METROPOLITAN GOVERNMENT OF NASHVILLE AND DAVIDSON COUNTY

Metropolitan Historic Zoning Commission
Sunnyside in Sevier Park
3000 Granny White Pike
Nashville, Tennessee 37204
Telephone: (615) 862-7970
Fax: (615) 862-7974

STAFF RECOMMENDATION
3516 Richland Avenue
August 19, 2015

Application: New construction - addition
District: Richland-West End Neighborhood Conservation Zoning Overlay
Council District: 24
Map and Parcel Number: 10405039500
Applicant: Zach Provonchee, Architect
Project Lead: Sean Alexander, sean.alexander@nashville.gov

site plan 3516 Richland Ave

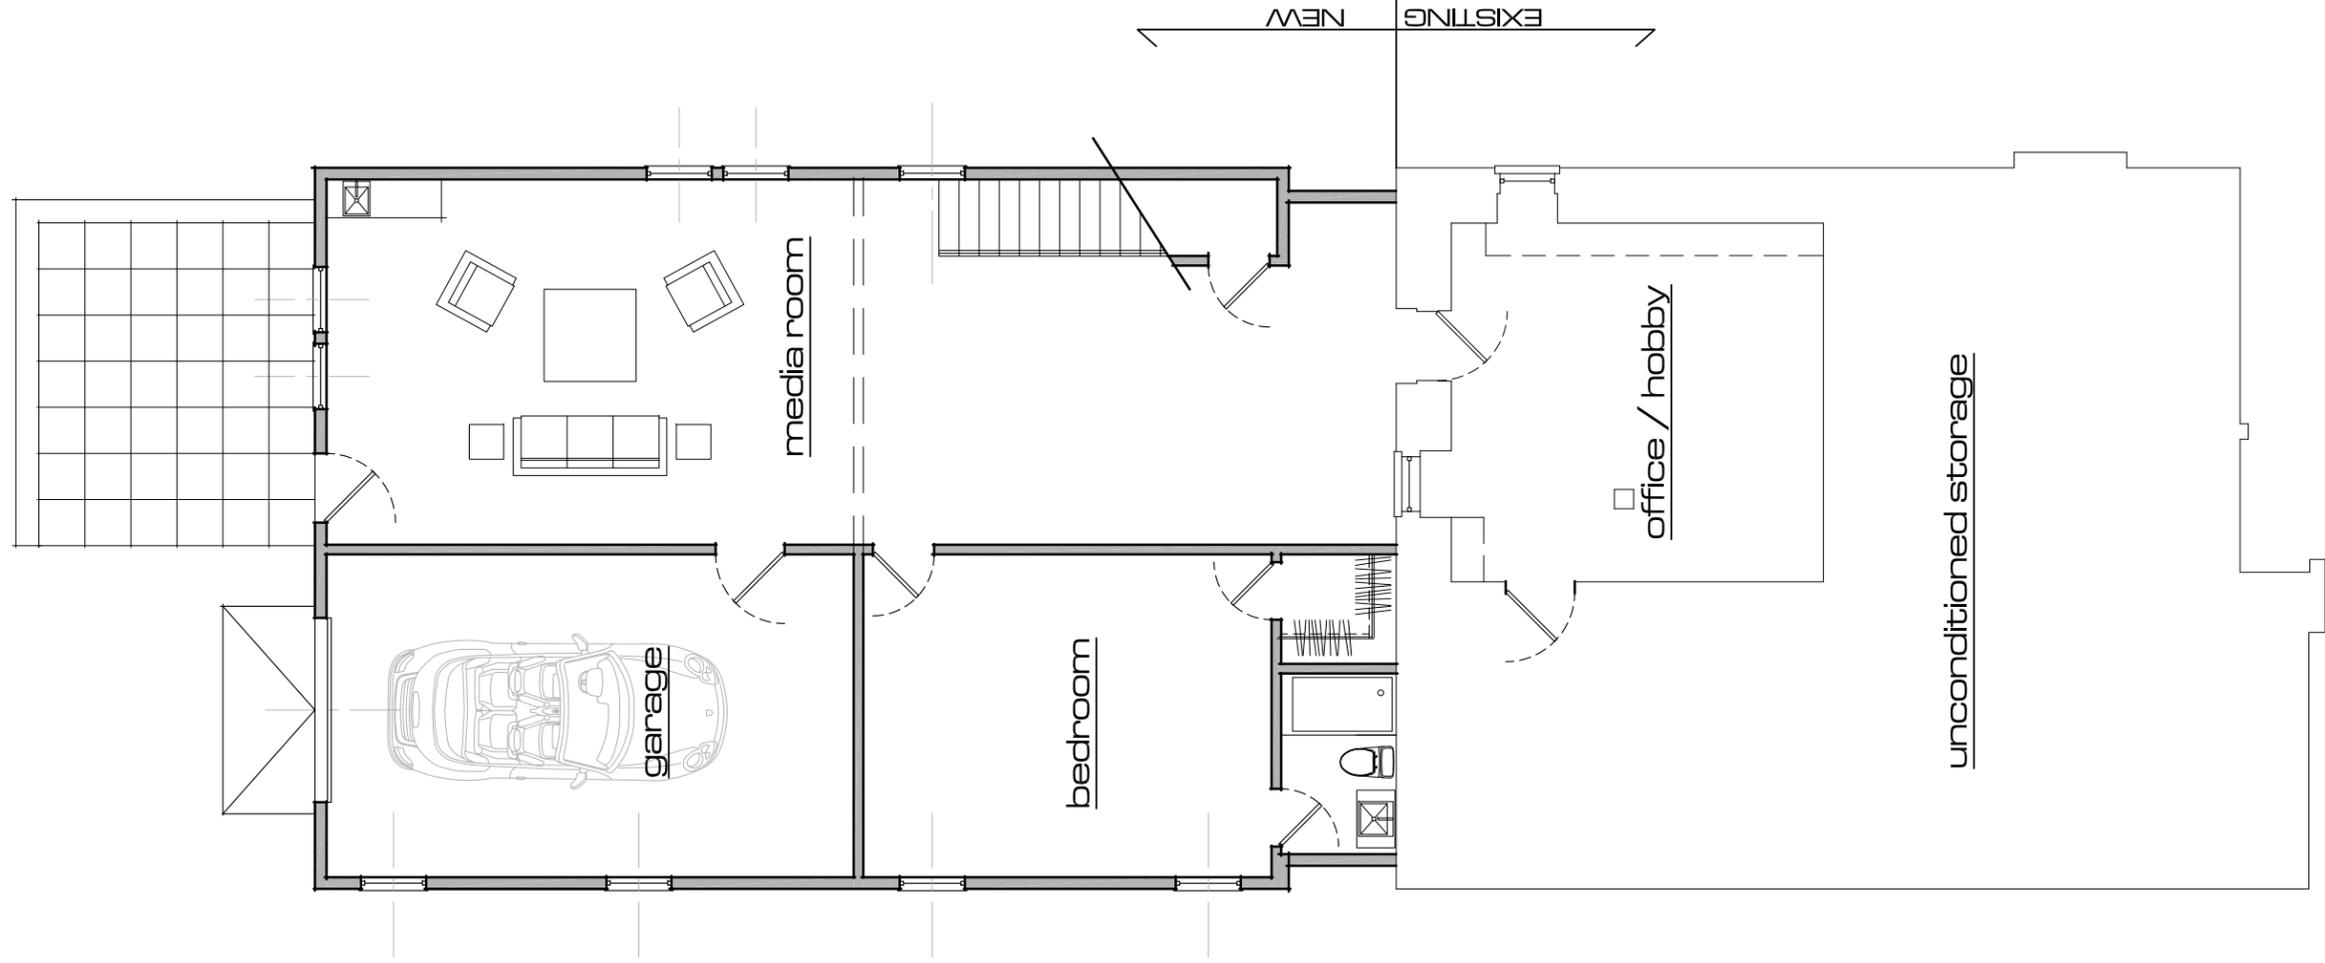
Location & Removability: The addition will be located behind the existing building, setting in from the side walls of the historic house by one foot (1') on each side. The roof of the addition will tie into the rear hip-ridges of the existing roof with no inset. Typically, additions are required to be distinguished from an historic building by maintaining the rear corners, eaves, and rafters. By stepping in from the sides and the roof, the addition would not directly impact the integrity and form of the original

structure. With a condition that the roof be inset from the existing roof slopes, Staff finds that the project would meet sections II.B.2.a and II.B.2.d of the design guidelines.

Height & Scale: The walls of the addition will sit in from the sides of the house by one foot (1') on each side, then extend back four feet, six inches (4'-6") before stepping back out to match the width of the house. The addition will then extend back another forty-two feet (42'). Together, the primary component of the addition and the connector will be forty-seven feet (47') deep front-to-back, seven feet (7') greater than the original house. The roof of the addition will tie in directly to the existing roof, flush with the side slopes and matching the existing ridge and eave height.

While the alcove separating the walls of the new construction from the existing help to identify where the addition begins, Staff finds that the scale of the addition is not subordinate to the historic house. By matching the height and not stepping in the roof, stepping the walls back out to match the width, and because the addition is deeper front-to-back than the existing structure, the resulting structure would be more new construction than historic. Staff recommends that the addition be more physically distinguished from the historic house and that the scale be reduced by stepping the roof in from existing roof's side slopes and down from the ridge and either Stepping the side walls of the addition in from the sides of the existing house without stepping back out or reducing the depth of the addition to be less than that of the historic house.

1. The roof is stepped in from existing roof's side slopes and down from the ridge, and
 - a. step in the addition from both sides of the existing house without stepping back out; and/or
 - b. reduce the depth of the addition to be less than that of the historic house.
2. The selections of windows and doors are approved by Staff prior to installation and purchase.

proposed lower level

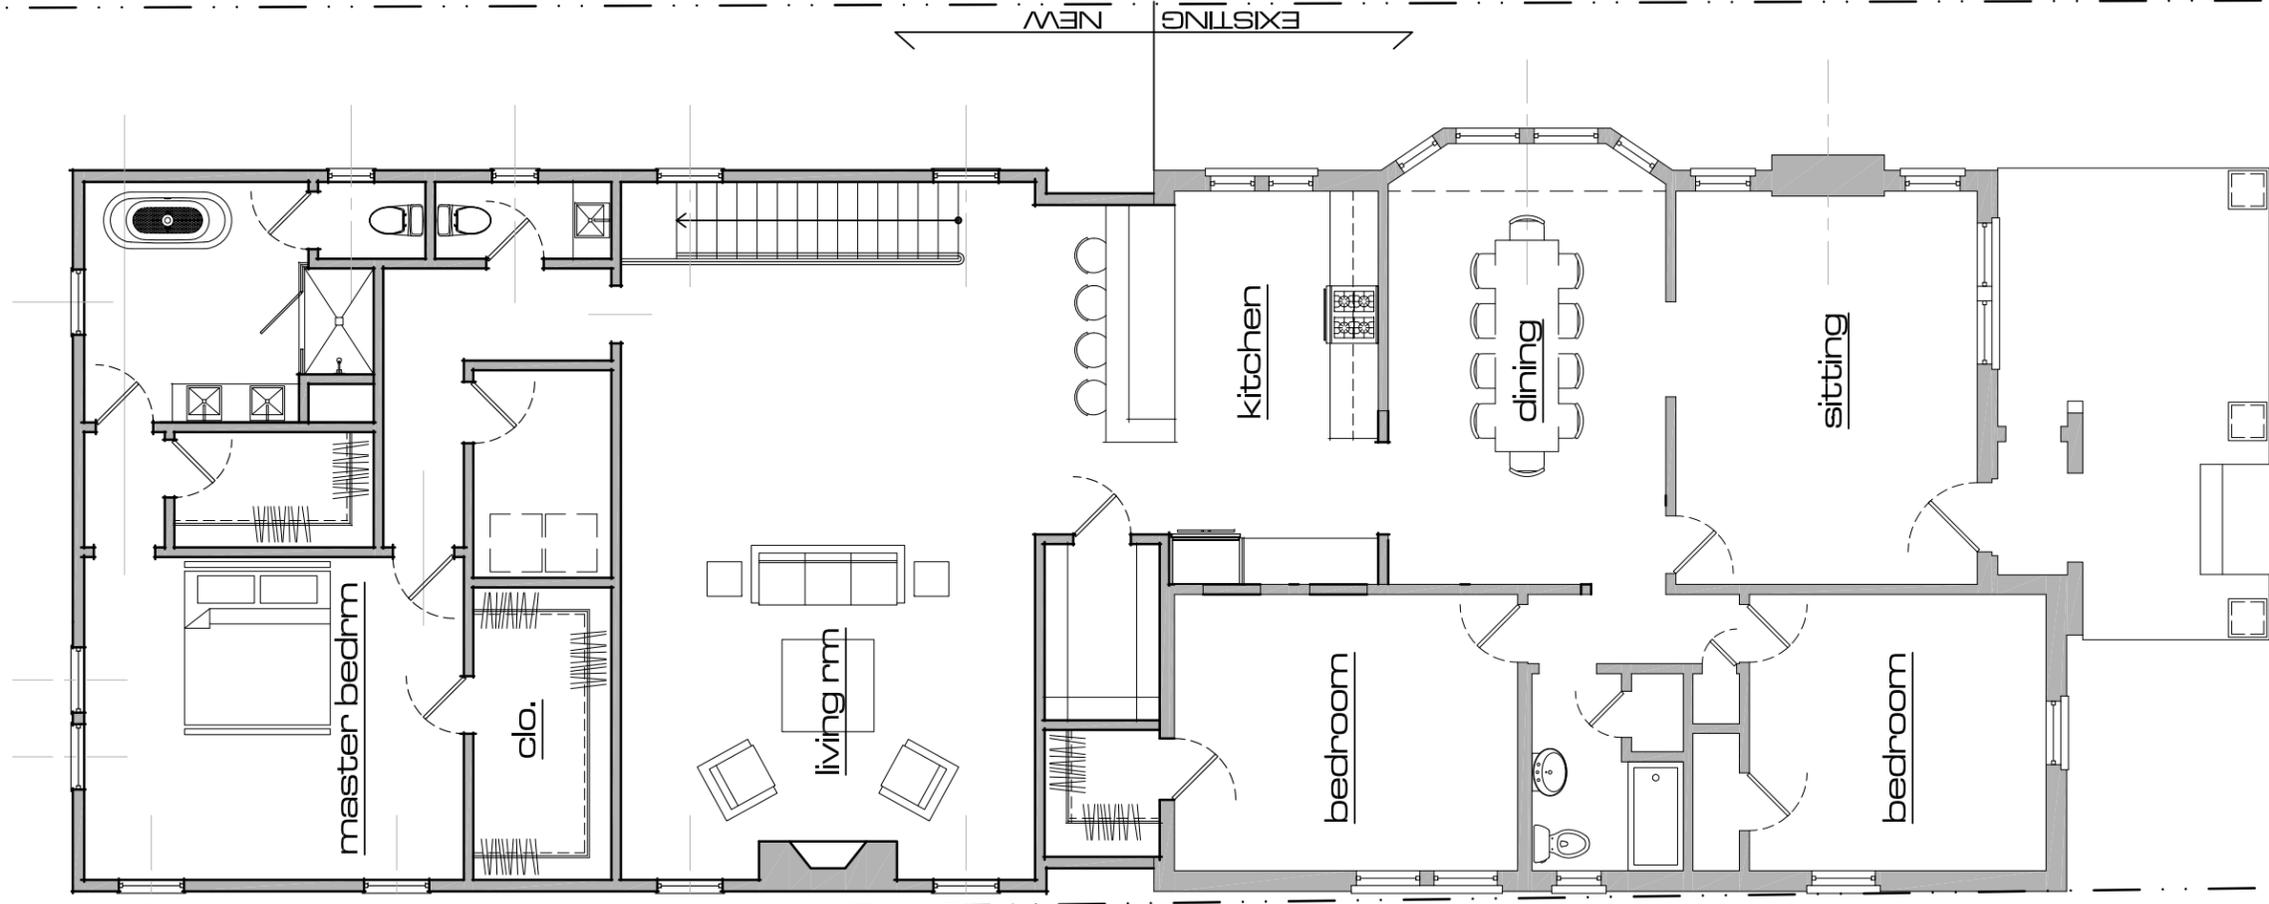
Because the grade drops significantly to the rear, the addition will gain a full story at the rear below the existing first floor level. Although below grade of the lot at the front, the additional level matching the width of the existing structure but exceeding its depth contribute to the scale of the addition and reinforce Staff's conclusion that the addition is not subordinate to the house. Staff finds that the scale of the addition is not subordinate to the historic house, and that the project proposed does not meet sections II.B.1.a and II.B.1.b of the design guidelines.

Outbuildings: The proposed addition will include a garage in the basement level gained by the drop in grade. Although attached garages would generally not be appropriate, in locations where they are below street-grade, are accessed from the rear, and are in the location of other historic garages nearby, the Commission has found them to be appropriate. This garage meets these criteria. Staff finds that the project meets section II.B.1.h of the design guidelines.

proposed west elevation

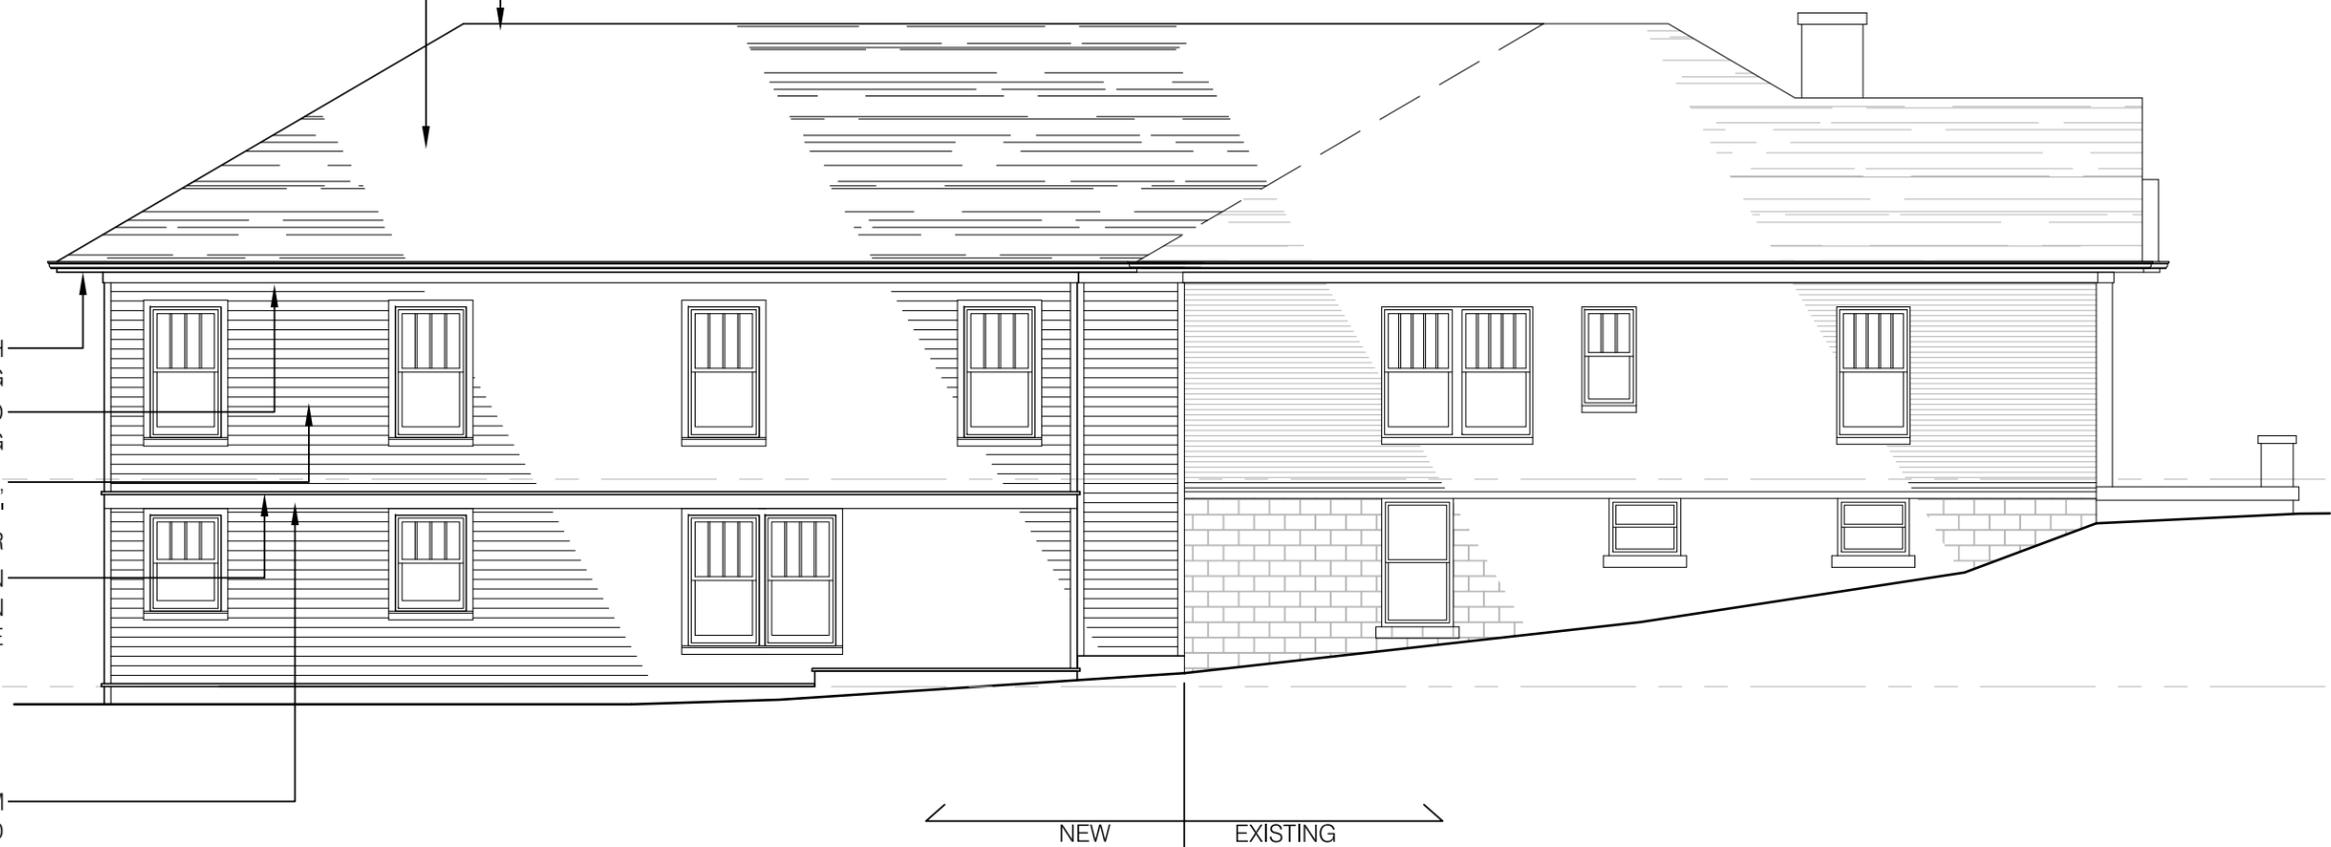
Materials: No changes to the historic house's materials were indicated on the drawings. The addition will primarily be clad in smooth-faced cement fiberboard with a reveal of five inches (5") on both the main floor level and the additional level below gained by the drop in grade. An eight inch (8") wide trim band between the levels will define the level of the main floor. The trim will also be cement-fiberboard. The foundation will be concrete block with a parge-coat finish, and the roof will be architectural fiberglass shingles in a color to match the existing roof. The windows and doors are not known at this time, so staff asks to approve their selections prior to purchase and installation. With the staff's final approval of the windows and doors, staff finds that the known materials meet section II.B.1.d of the design guidelines.

Roof form: The roof will tie into the existing hipped roof, flush with the side slopes and matching the original roof ridge height. The new roof will extend back forty-seven feet (47') to the rear with a hip matching the existing 7:12 pitch. Staff finds that the new roof, without separation or distinction from the original hipped roof, would inappropriately alter the form of the original roof and impair its historic integrity. Staff finds that the project proposed does not meet section II.B.1.e of the design guidelines.

Proportion and Rhythm of Openings: No changes to the window and door openings on the existing house were indicated on the plans. The windows on the proposed addition are all generally twice as tall as they are wide, compatible with the proportions of openings on the historic building. There are no large expanses of wall space without a window or door opening. Staff finds the project's proportion and rhythm of openings to meet Section II.B.1.g.
